RUSTIC RAVINES RESORT

ADDENDUM #1

JUNE 8, 2022

THRASHER PROJECT #030-10264

SHEET No.
U1

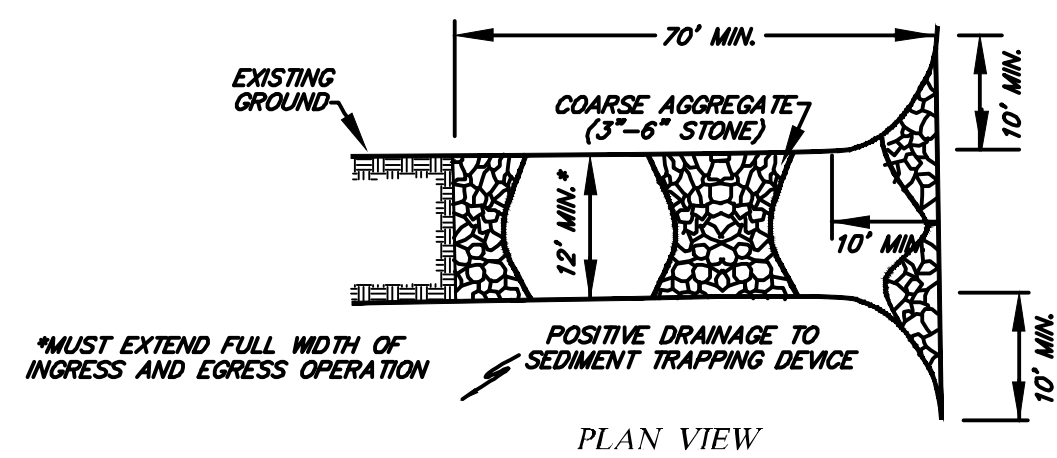
Sheet U1 – Proposed Overhead Electric power line was labeled to clarify it will be installed by AEP.

1. This contract will not include the overhead power line from the existing power pole to the new power pole with transformer. This line, new pole, and transformer will be provided and installed by AEP.

NO.	BY	DATE	DESCRIPTION
1	JH	6.8.2022	CLARIFICATION OF AEP RESPONSIBILITIES
